BRUNSWICK STEAM ELECTRIC PLANT, UNIT NOS. 1 AND 2  
DOCKET NOS. 50-325 AND 50-324/LICENSE NOS. DPR-71 AND DPR-62  
RESPONSE TO REQUEST FOR ADDITIONAL INFORMATION - REQUEST FOR  
LICENSE AMENDMENTS TO ADOPT ALTERNATIVE RADIOLOGICAL SOURCE  
TERM (NRC TAC NOS. MB2570 AND MB2571)

Response to Request For Additional Information (RAI) AST 3

BSEP Unit 1: Main steam drain line and spring and strut supports in the Reactor Building MSIV pit.

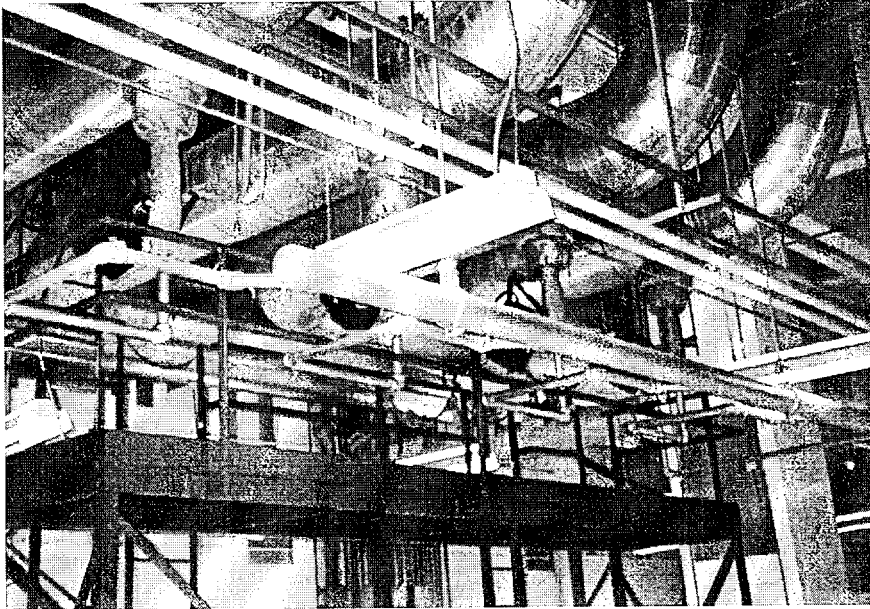
In discussion under NRC limitation 2, you stated that the design attributes of the BSEP piping and supports were compared to the attributes of the database piping and supports as shown in Tables 4-3 through 4-6. The referenced tables do not show any comparison of design attributes of the database piping supports with the BSEP piping supports. Provide a comparison that was performed for piping support attributes. For the most critical pipe support, provide a basis for the selection of the governing support and summary of seismic load calculation, load combination, and method of analysis considered in the evaluation. Also, provide a summary of evaluation results including the maximum calculated stress, allowable stress, Code, and Code Edition used for evaluating the most critical components.

For pipe support comparisons, refer to Section 4.3 of the enclosure to CP&L's submittal dated September 27, 2001 (Serial: BSEP 01-0112), which describes the earthquake experience-based approach to review the design attributes of the BSEP piping and related supports in order to demonstrate that they fall within the bounds of the experience database. Briefly stated, the Brunswick ALT piping systems consist of welded steel pipe and standard support components. Typical standard support components utilized at BSEP include single rod hangers or rod-hung trapezes, variable spring hangers, and welded steel angle trapezes or cantilever brackets with U-bolts. Some typical BSEP pipe support configurations are shown in the following figures.
